LICENSEE: Nuclear Management Company, LLC  
FACILITY: Point Beach Nuclear Plant, Units 1 and 2  
SUBJECT: SUMMARY OF TELEPHONE CONFERENCE HELD ON JANUARY 10, 2005,  
BETWEEN THE U.S. NUCLEAR REGULATORY COMMISSION AND  
NUCLEAR MANAGEMENT COMPANY, LLC, CONCERNING REQUESTS FOR  
ADDITIONAL INFORMATION PERTAINING TO THE POINT BEACH NUCLEAR  
PLANT, UNITS 1 AND 2, LICENSE RENEWAL APPLICATION

DRAFT REQUESTS FOR ADDITIONAL INFORMATION (RAI)  
POINT BEACH NUCLEAR PLANT, UNITS 1 AND 2  
LICENSE RENEWAL APPLICATION

### RESPONSE TO REQUEST FOR ADDITIONAL INFORMATION POINT BEACH NUCLEAR PLANT, UNITS 1 & 2 LICENSE RENEWAL APPLICATION

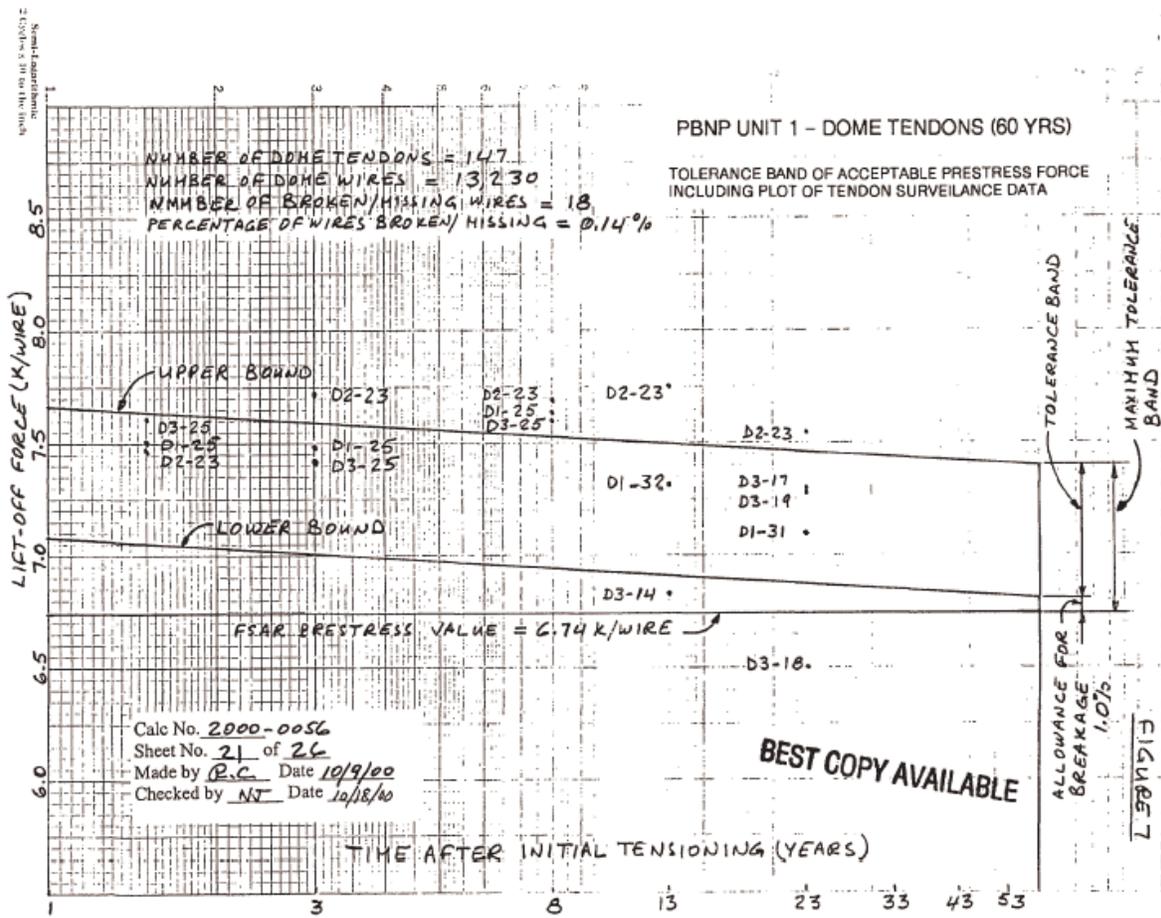
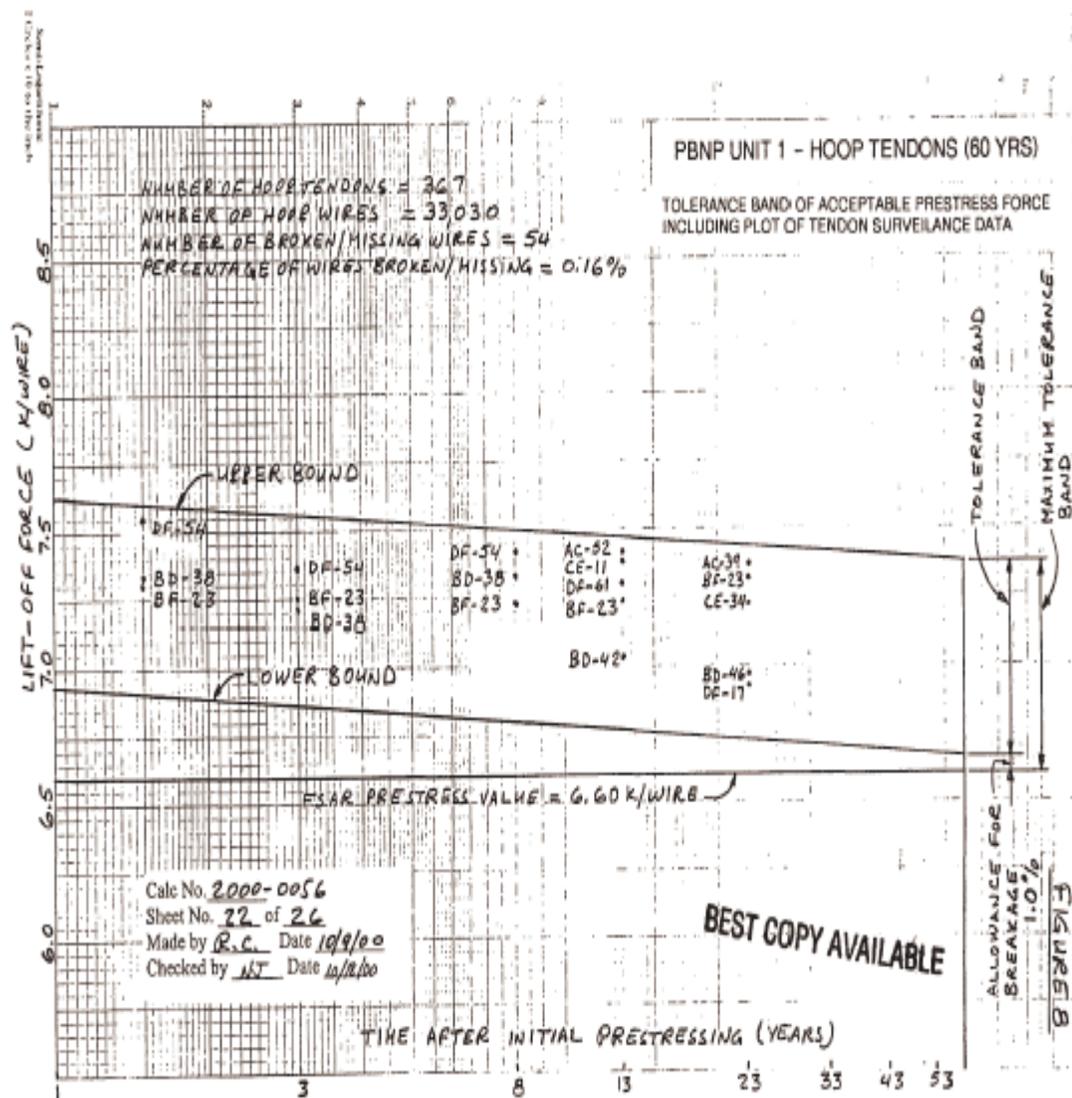
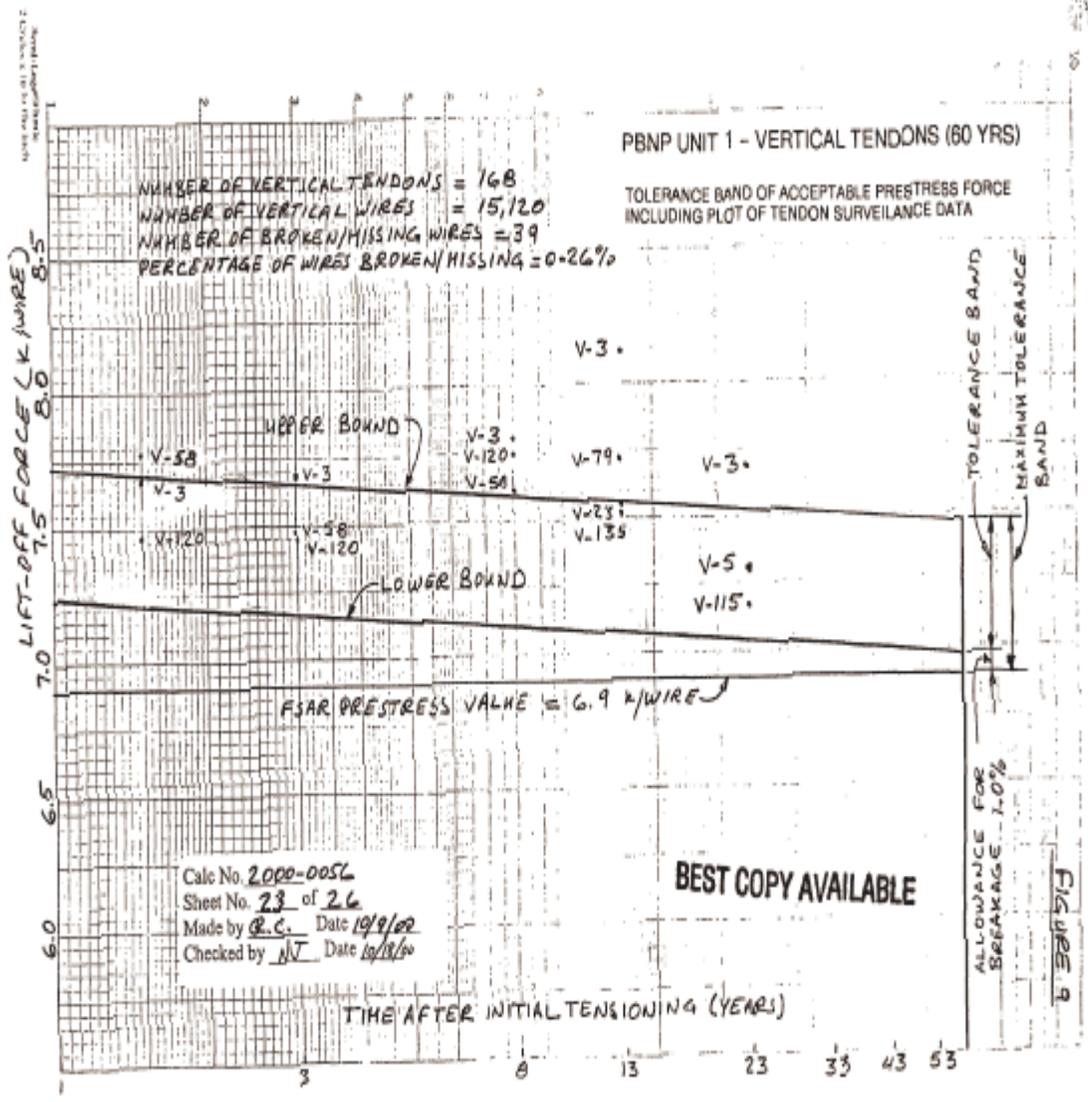
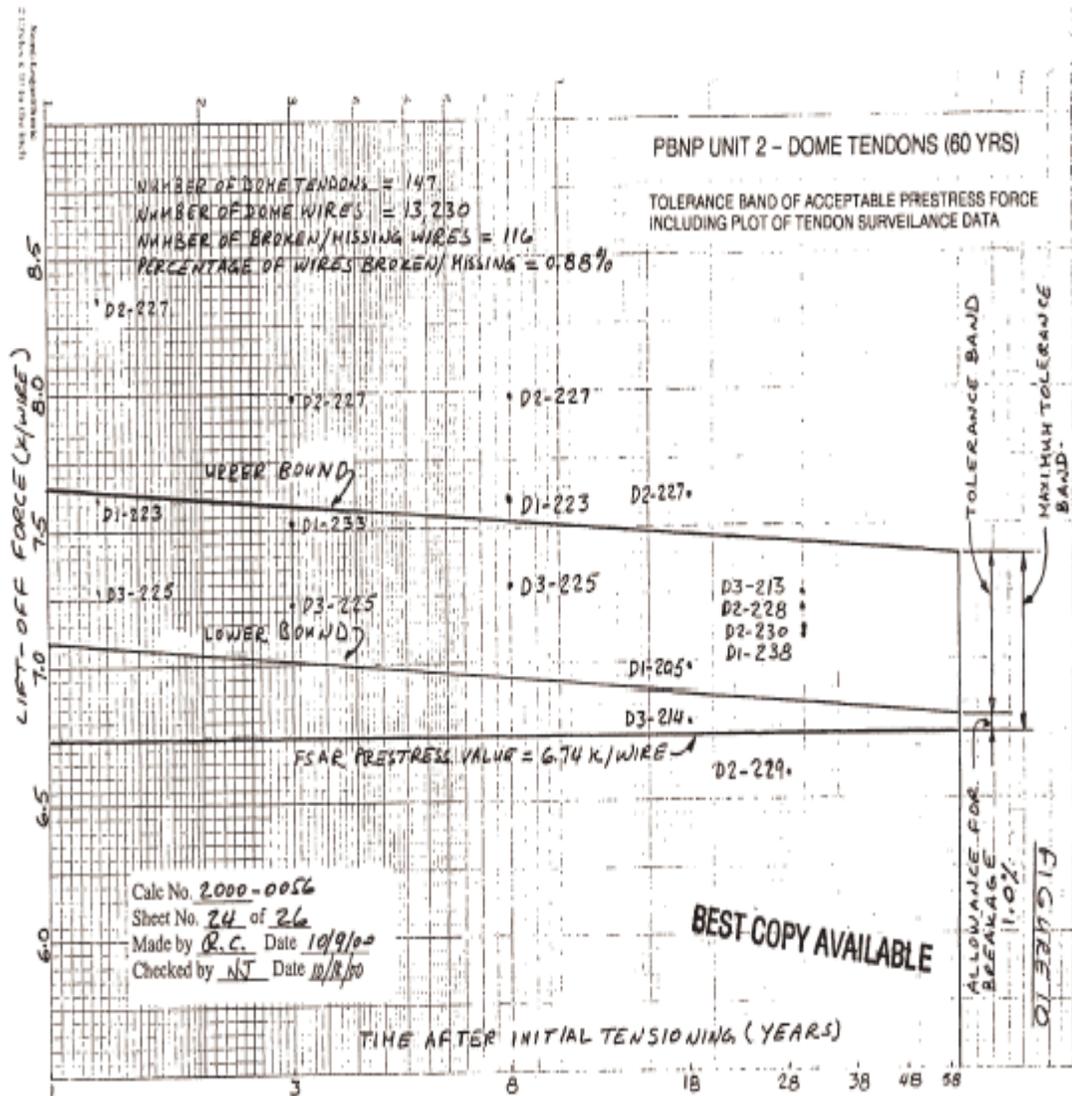
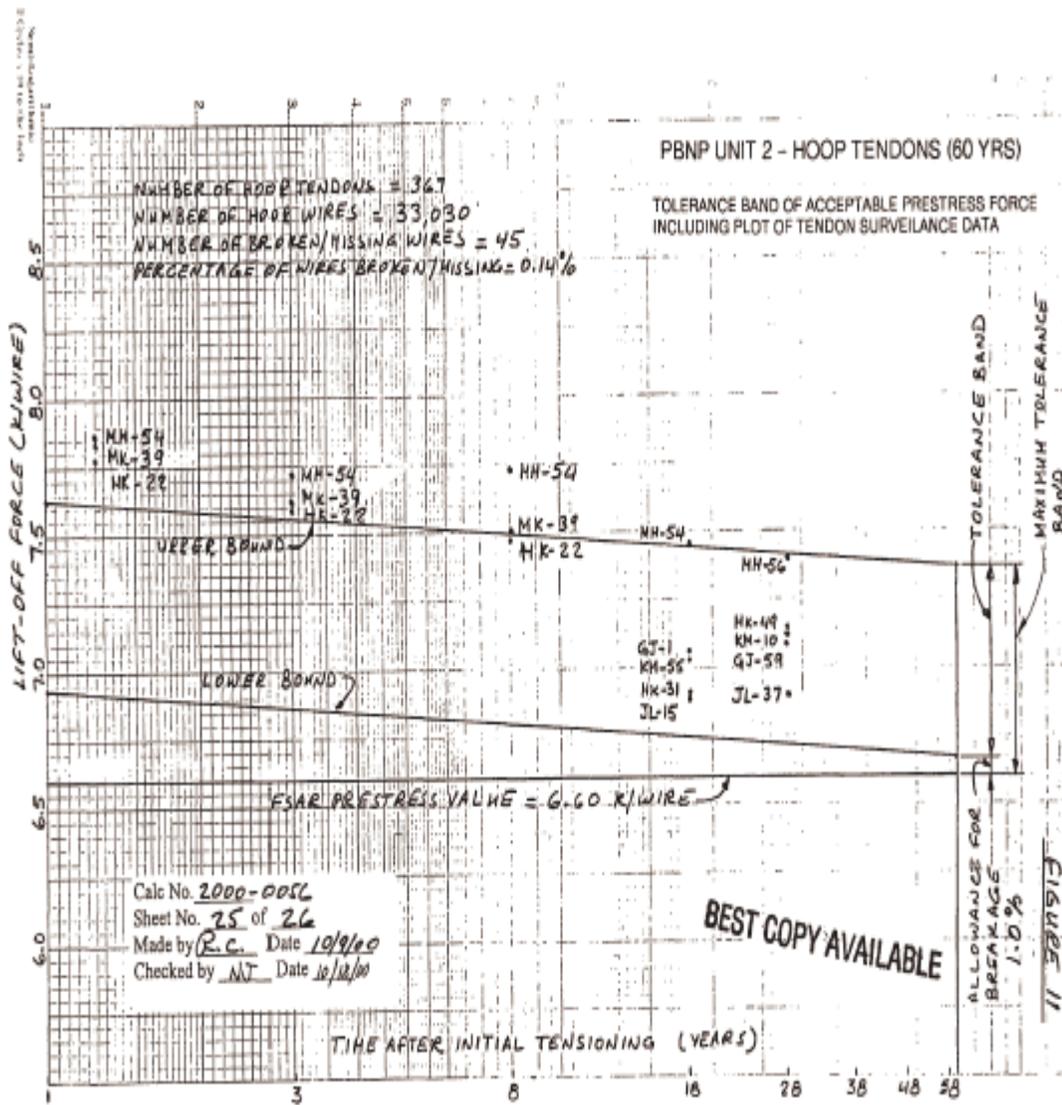
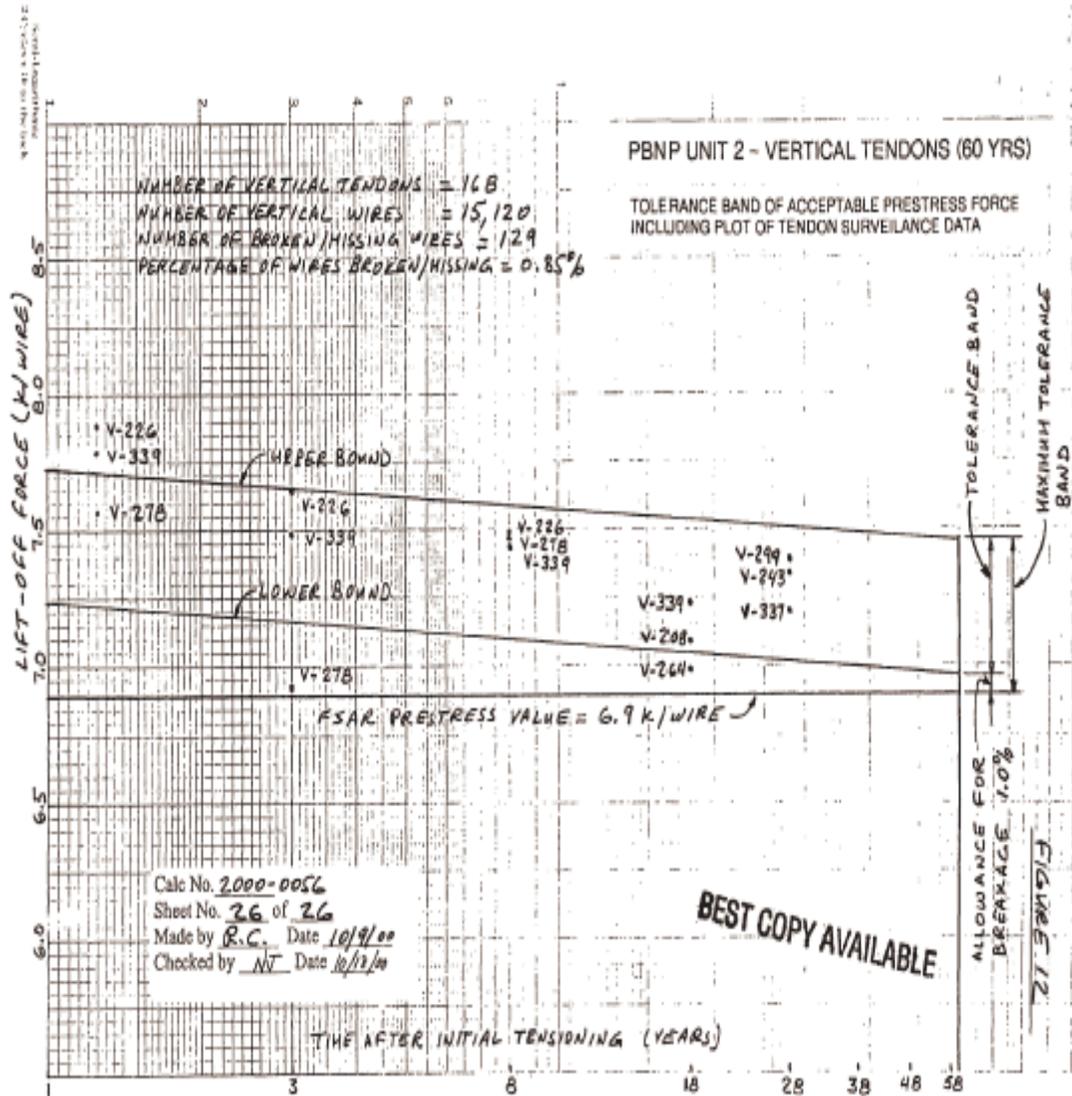
The use of 10 CFR 54.21(c)(1)(ii) and (iii) is appropriate for concrete containment tendon prestress TLAA. However, the staff need to assess the plant specific operating experience regarding the residual prestressing forces in the containments and the methods used to arrive at the projected prestress forces. Based on the analysis performed as per 10 CFR 54.21(c)(1)(ii), the applicant is requested to provide the following information:

- a. The estimated upper and lower bound lines, and the minimum required prestressing forces for each group of tendons for each containment.
- b. Trend lines of the projected prestressing forces for each group of tendons based on the regression analysis of the measured prestressing forces (see NRC Information Notice 99-10 for more information). Also, show the actual measured prestressing forces that were used to obtain the trend lines.
- c. Plots showing comparisons of prestressing forces projected to 40 years and 60 years with the minimum required prestress (or MRV) for each group of tendons for each containment.

A set of tendon prestressing plots have been developed in accordance with RG 1.35.1, reference Calculation 2000-0056, Tendon Prestress Acceptance Limits, Rev. 0. The plots for 60 years (6 total) include the upper and lower bound lines and the minimum required prestressing force for each group of tendons for each of the containments per RG 1.35.1.
